Revisions and Errata List
AISC Steel Design Guide 24, 1st Printing (Printed Copy)
October 15, 2012

The following list represents corrections to the first printing of AISC Design Guide 24, *Hollow Structural Section Connections*.

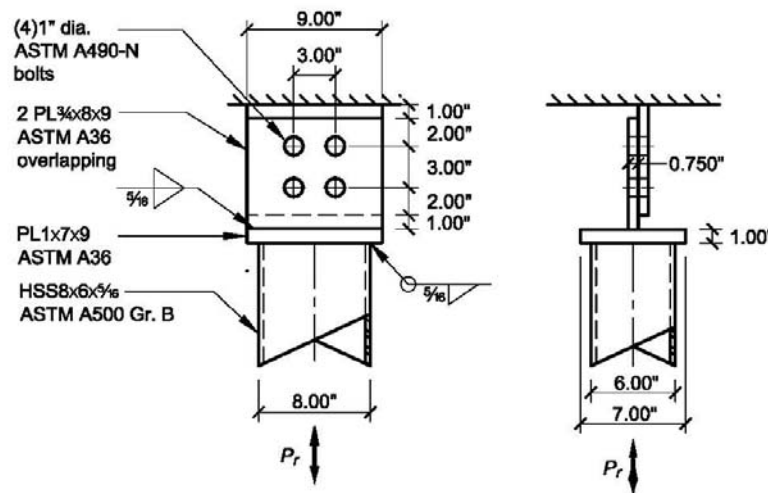
55	Figure 5-9 should be revised so that the connection plate dimensions are as shown in the figure below:
----	--
